February 22, 2024

RE: Status of CU 24-01, DR 24-01, & ZA 24-01 "US Market gas station" at 2115 Molalla Rd (Tax Lots 051W09B001000, 1100, & 1200 [primary])

Staff reviewed the degree of completion of the Conditional Use (CU) consolidated applications package for the subject property with materials submitted January 23, 2024 and determined it incomplete as of February 22, 2024. Staff sends this letter to demonstrate compliance with Oregon Revised Statutes (ORS) [227.178\(2\)](#).

**C100**

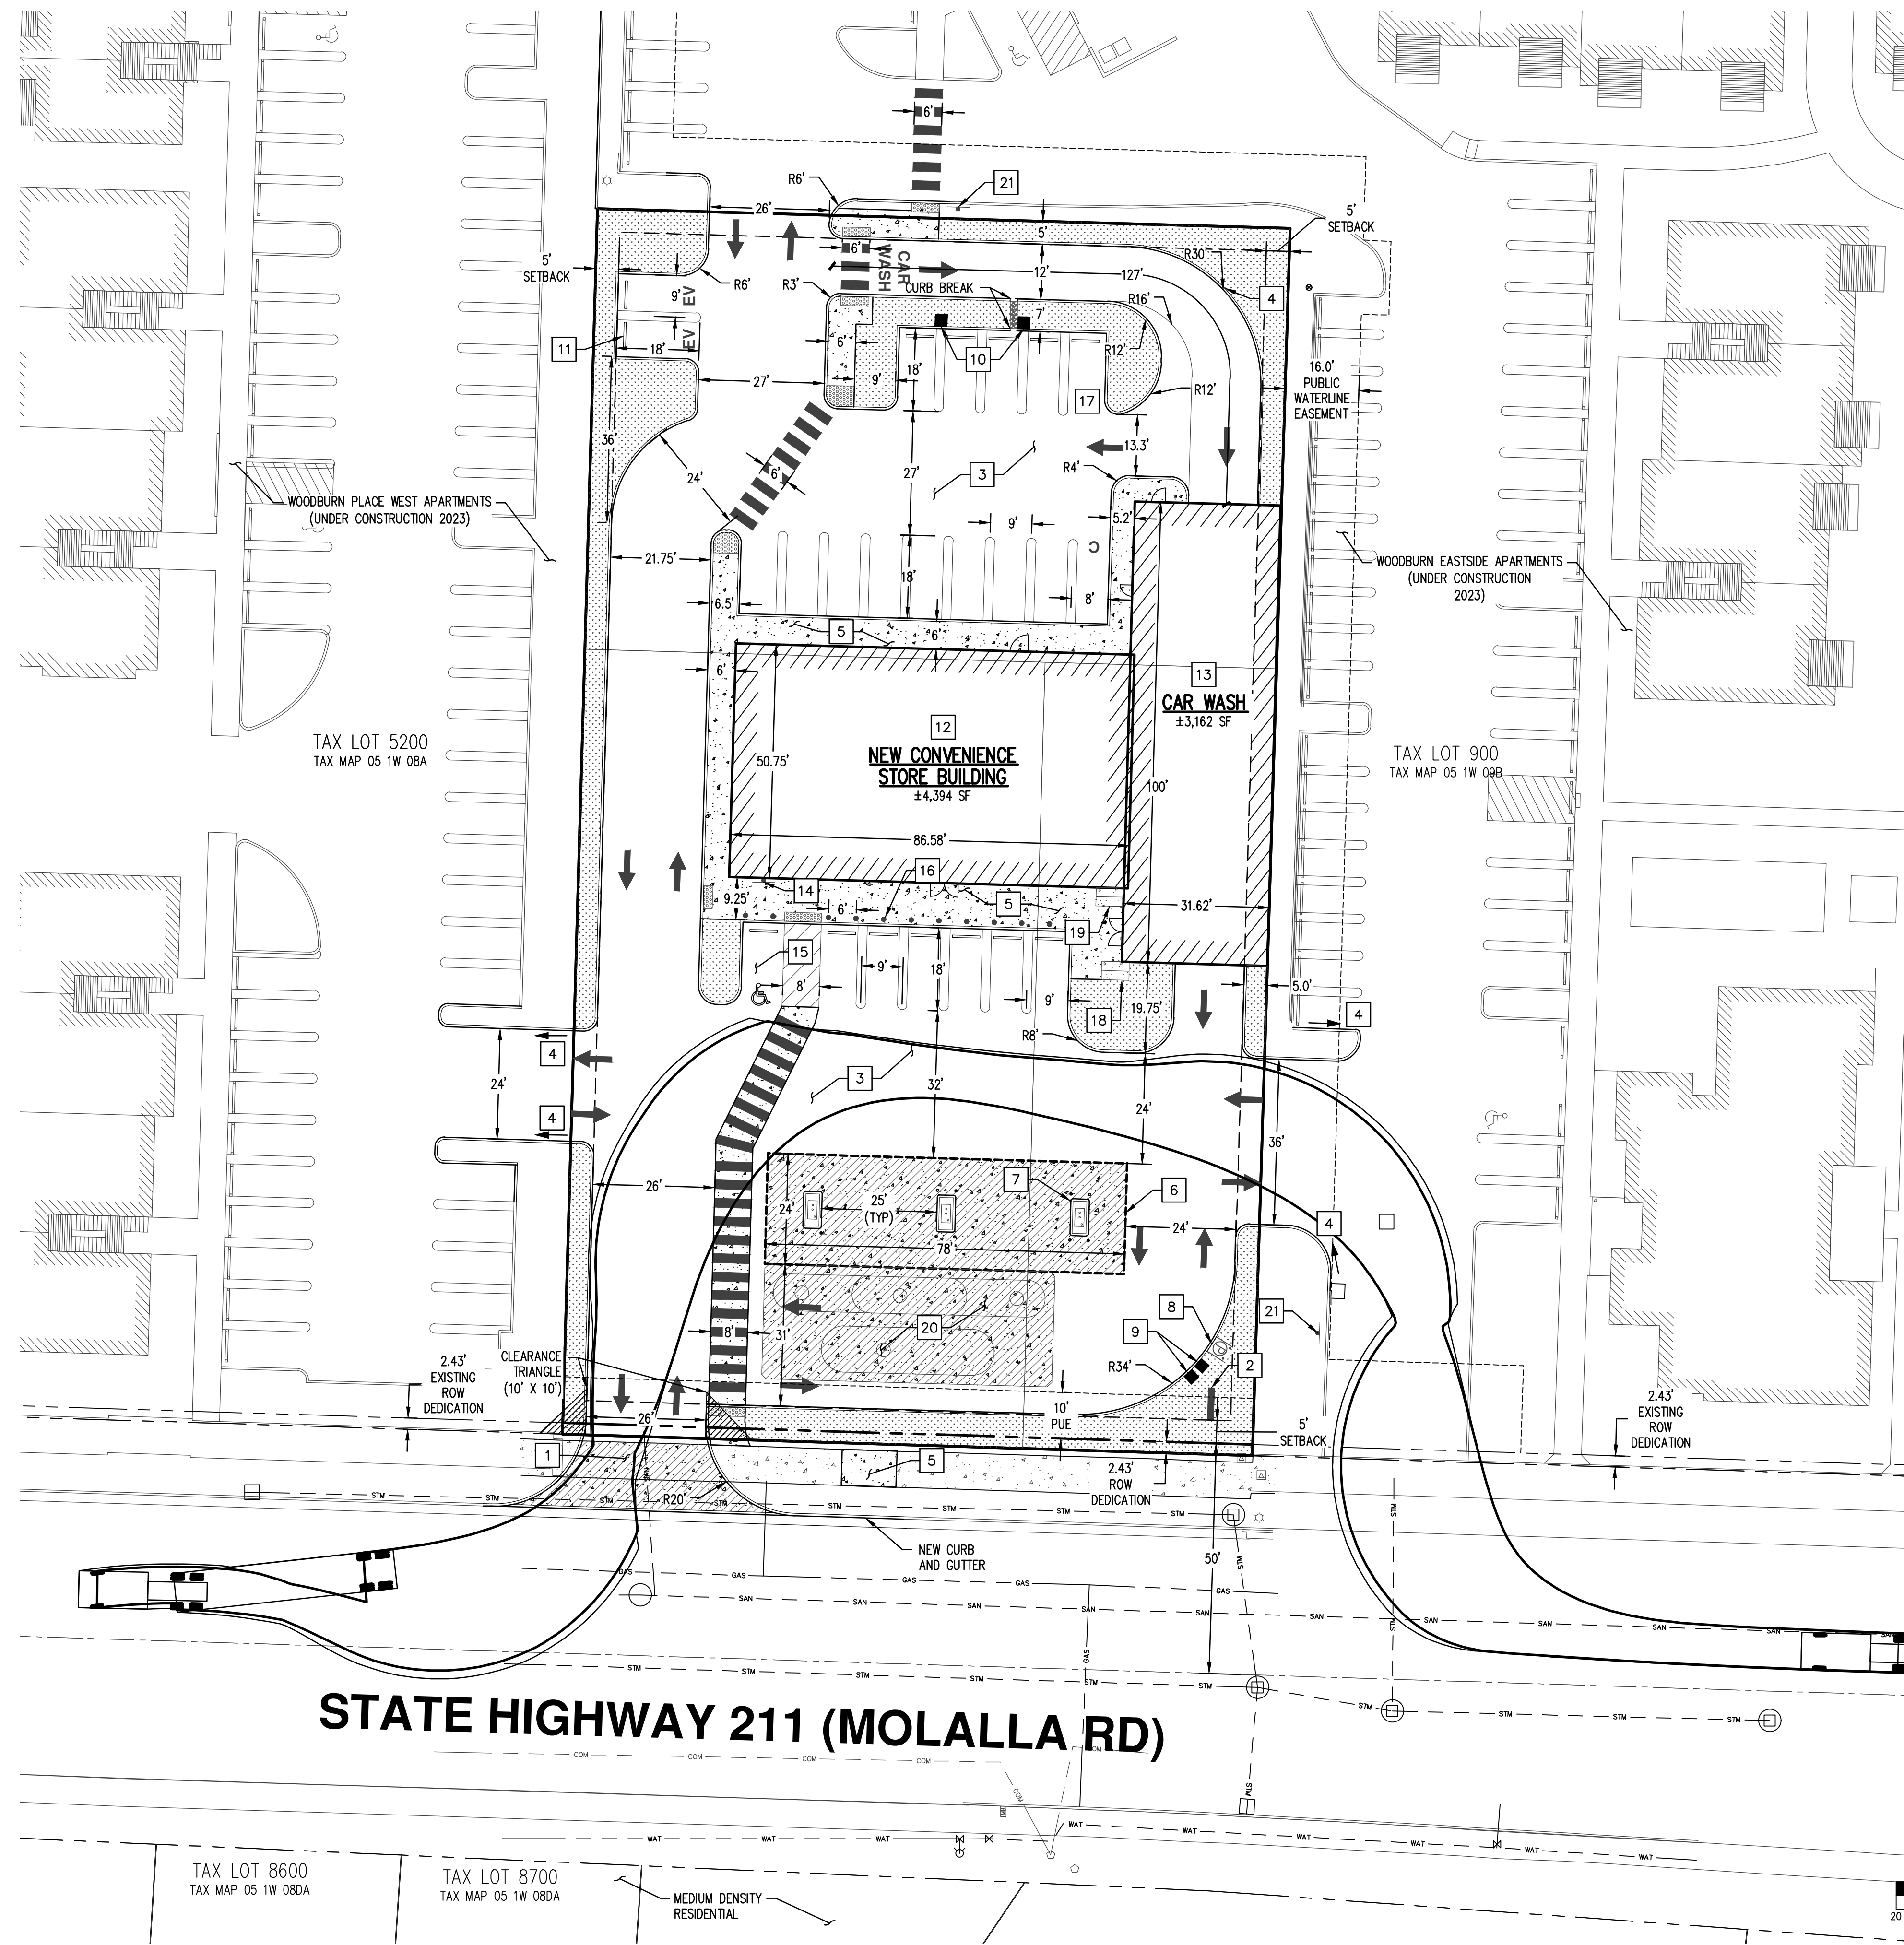
- 2. Demonstrate that the landscape strip conforms with the 3.01.04B last paragraph (grass and irrigation).
- C. Vision clearance area (VCA) / sight triangles: Revise the site plan sight triangles to shift them north to align with the post-dedication right-of-way (ROW) boundary instead of the existing one, in order to conform with Figure 3.03A.

- 2. Revise Sheet C100 and its keyed Note 1 to (a) symbolize a driveway apron that conforms with standard drawings [4150-1](#) & 4150-4 and (b) end the note with, "conforming with City of Woodburn Public Works unless the Oregon Dept. of Transportation in writing directs otherwise".

- 2. Oregon Department of Transportation (ODOT) comment 1 from the enclosed memo of February 21 (Enclosure 3).
- G. Bicycle parking: The site plan indicates through Keyed Note 19 for covered bicycle parking that it is, “covered by building overhang”. Elevation Sheet A3.1 does not allow determination of conformance – that the roof overhang of the convenience store is at least 4 ft deep, enough to span the two 2-ft wide bicycle parking stalls. Use any of drawings and text to demonstrate conformance.

1. Minimum parking: The proposed use requires minimum 25 parking stalls, which the narrative under Table 3.05A correctly describes, but the site plans illustrate only 23 stalls.

6. Carpool/vanpool (C/V): The narrative under Table 3.05C says that the site plan has a C/V stall at the north rear of the convenience store, but there is none – unless the stall marked with a bold gray “C” means to indicate C/V instead of a compact stall. Revise the site plan to designate the C/V stall as “C/V” on the site plan.

- N. Pumps: Revise site plan Keyed Note 7 to specify if the number of gas pumps is a half dozen (3 islands times 2 equals 6).
- O. Queueing: There appears too little room for vehicle queues at the pumps, and the application materials lack information about how queueing and circulation would operate. Guiding questions include:

- P. Water station: Explain what a “water station” is, which the site plan illustrates near the site southeast corner, revising Keyed Note 9 to describe.

AA. Cross access drive aisles: Revise the west cross access drive aisles from two-way at 24 ft wide with two striped arrows to one-way eastbound at minimum 10 ft and maximum 12 ft wide with one striped arrow and an *MUTCD*-compliant "do not enter" sign. (See also Part I, Item H).

**L100**

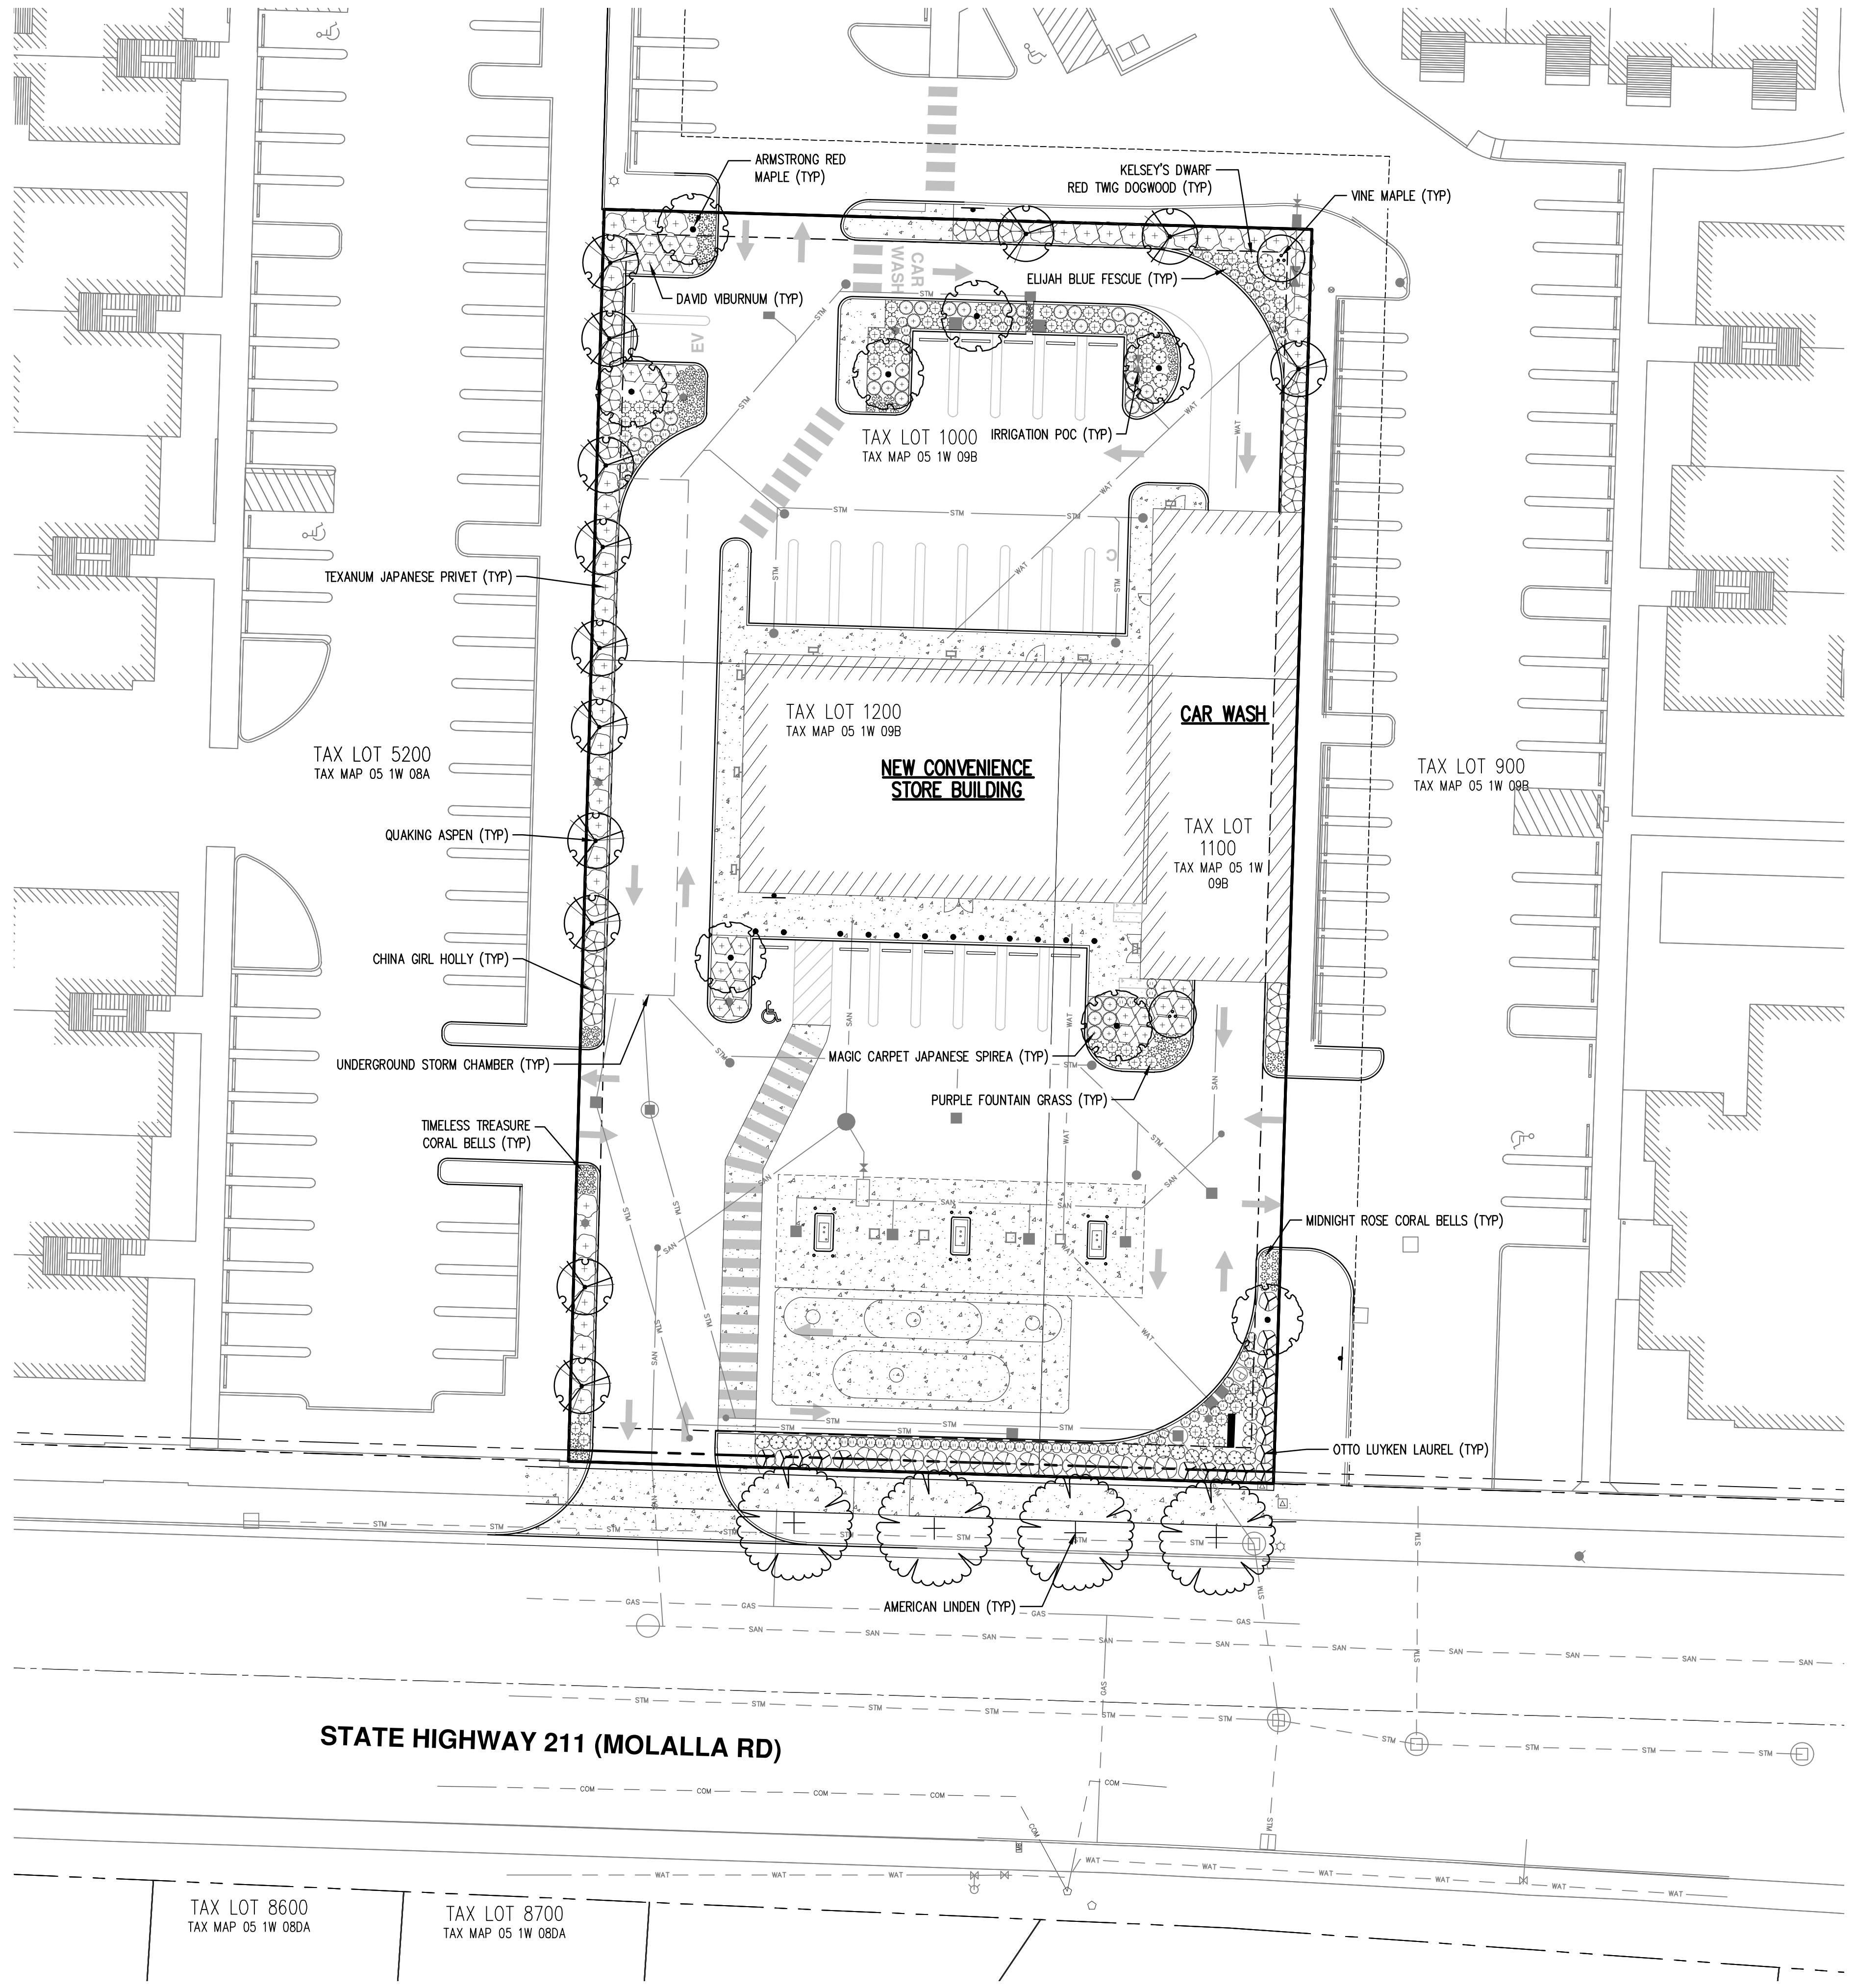
- B. Frontage/street improvements: Revise the Sheet L100 landscape plan to:
  - 1. Indicate in the legend for each tree species either the size category at maturity as Table 3.06B describes or height in feet at maturity.

- I. Walkway islands/peninsulas: To conform with 3.06.03C.4, revise the site and landscape plans to provide a landscaped island or peninsula along the west side of the wide walkway where it passes through the parking aisle at the convenience store. (Revision could change the walkway alignment.)
